Product Change Notification / SYST-29RHQU394

ERRATA - PIC18F24/25K40 Family Silicon Errata and Data Sheet Clarification

PIC18(L)F24/25K40 Family Silicon Errata and Data Sheet Clarification

Figure 1. 28-pin SPDIP, SSOP, SOIC

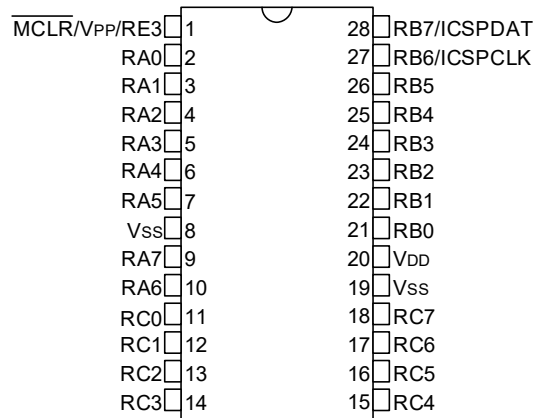
3.2.1 28-pin SPDIP/SSOP/SOIC Pin Diagram

The correct marking for pin 26 on the 28-pin SPDIP/SSOP/SOIC package is **RB5**.

Figure 38-10: ADC Conversion Timing (ADC Clock F_{OSC}-Based)

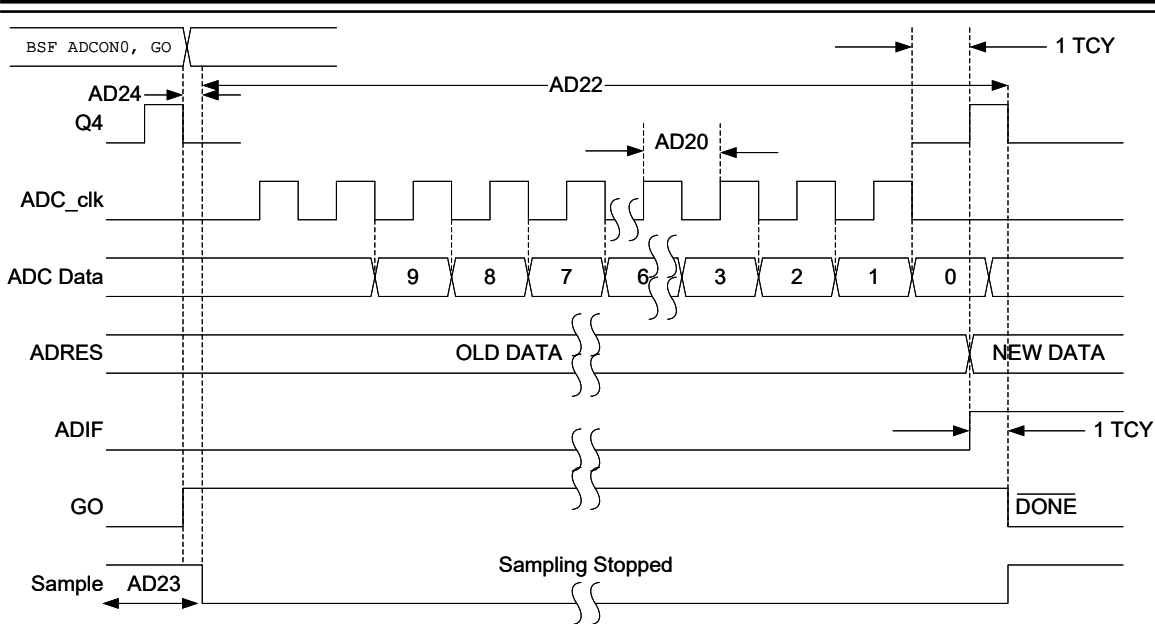
3.3.2 ADC Conversion Timing Diagram

Refer to the images below for corrections of Figure 38-10 and Figure 38-11. Previously, the parameter numbers were incorrect.
